Accessory Kit No. AK-118A
Supersedes AK-118

DATE: December 18, 1974

TITLE: Climb Propeller Accessory Kit
(For Use With McCauley Propeller 1A105/SCM7153 or
1A105/SCM7154)

MODELS AFFECTED: All Model AA-1 and AA-1A, and AA1B-0001 thru AA1B-0379

FIGURE 1

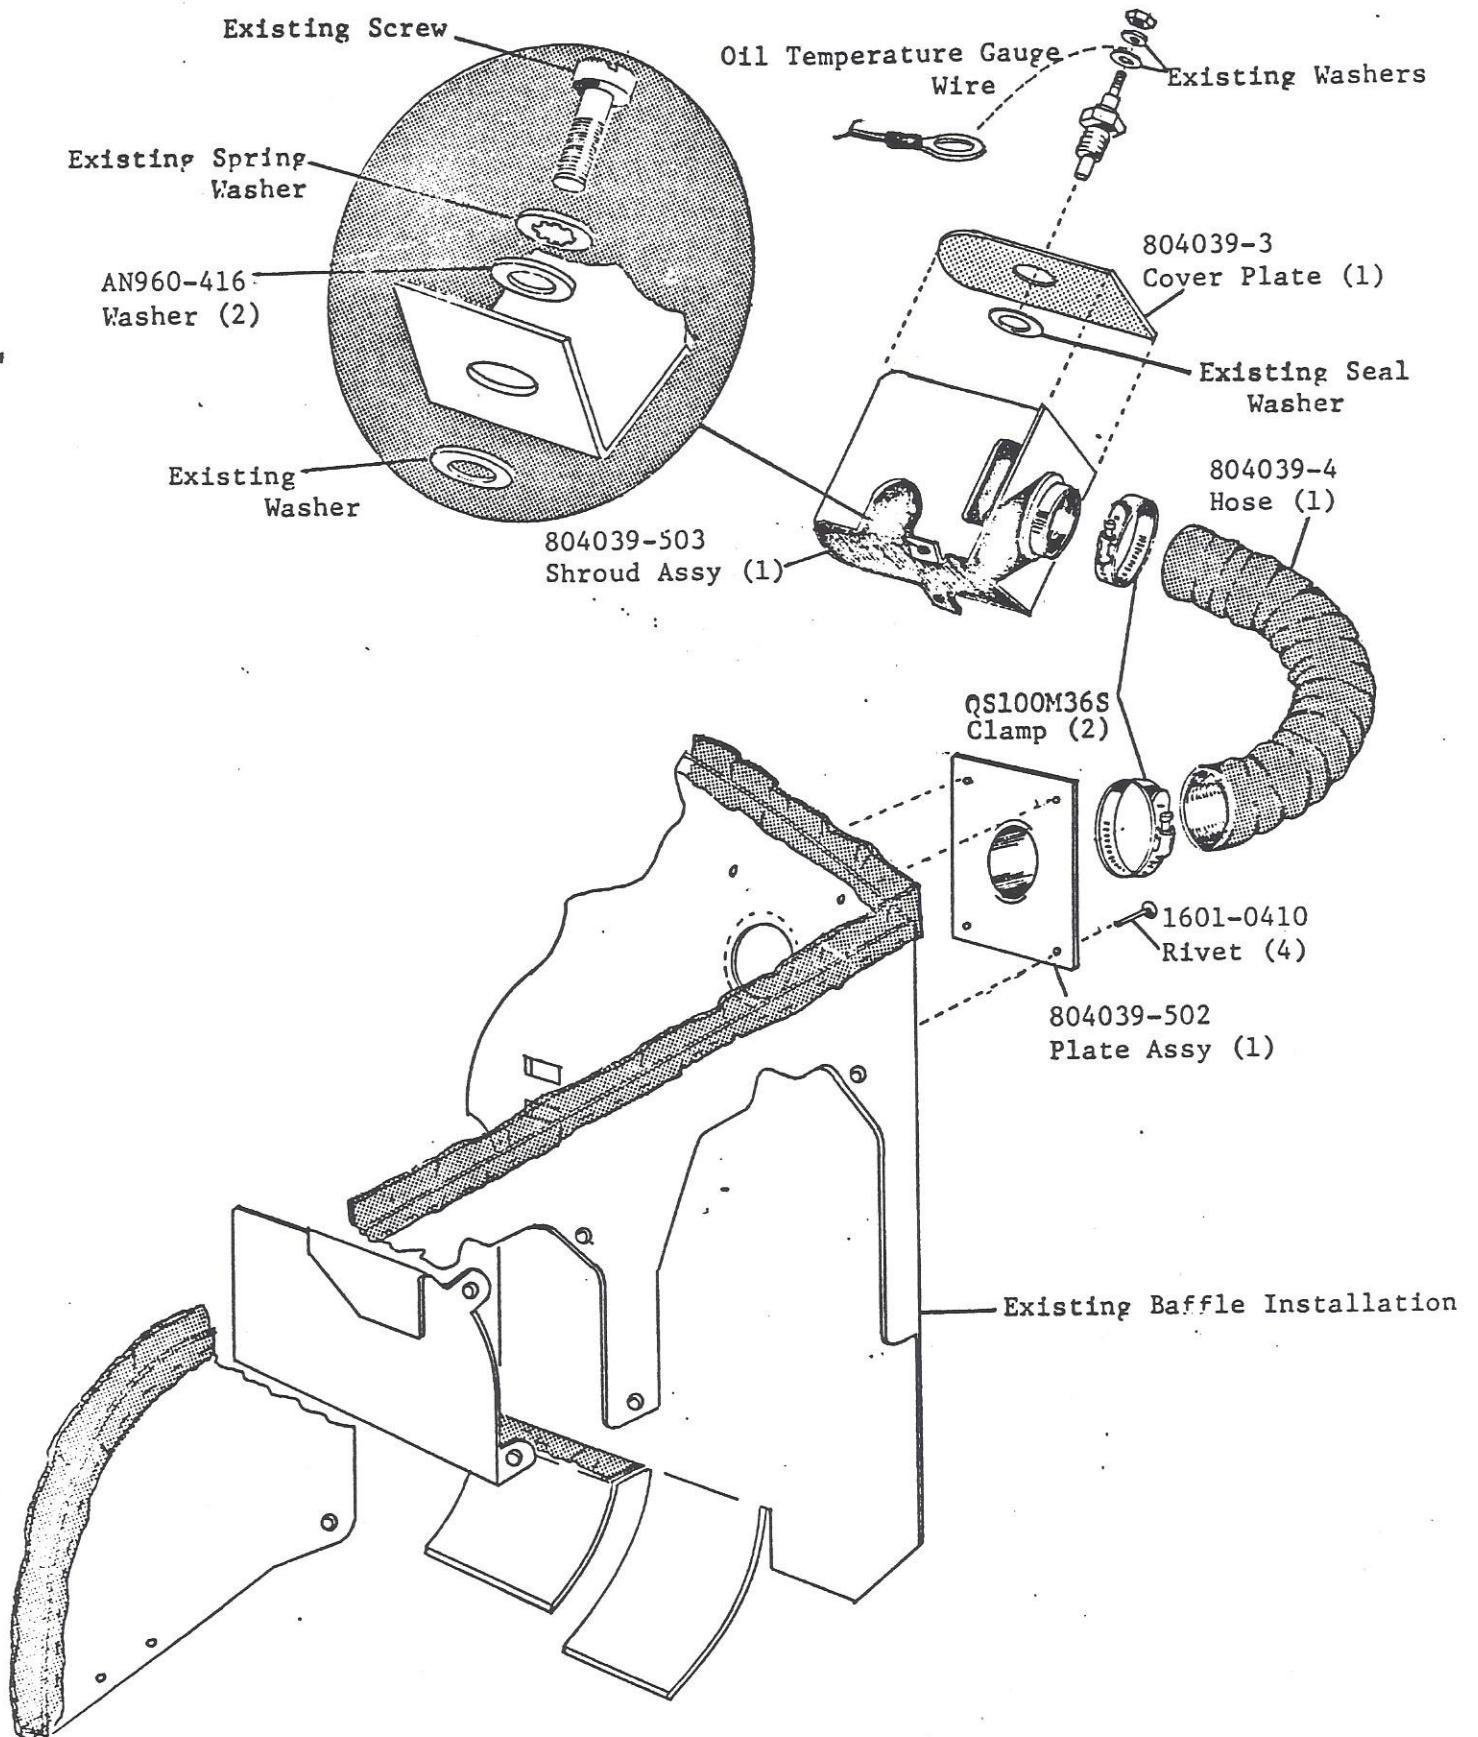
3. Remove the top and bottom two (2) screws which secure the screen housing to the engine accessory case. Fit shroud assembly (804039-503) over the screen housing, ensuring that the existing washers are below the housing feet. Add the two kit washers (AN960-416) above mount feet and the existing spring washers. Replace screws to the correct torque value (50/70 in. lbs.). See inset on figure 1.

4. Place threaded end of thermistor through hole in cover plate (804039-3). Slip existing seal washer over thread and push cover plate into shroud assembly. Screw thermistor into screen housing and retorque (140/160 in. lbs.). Re-attach oil temperature gauge wire to thermistor.

5. Assemble hose and two clamps so that the hose has a good twist-free run between the new 804039-502 plate assembly and the hose fitting on the shroud. Tighten the hose clamps and check that the existing baffle plates and seal strips are free of aluminium chips, clean and laying so as to provide good air seals.
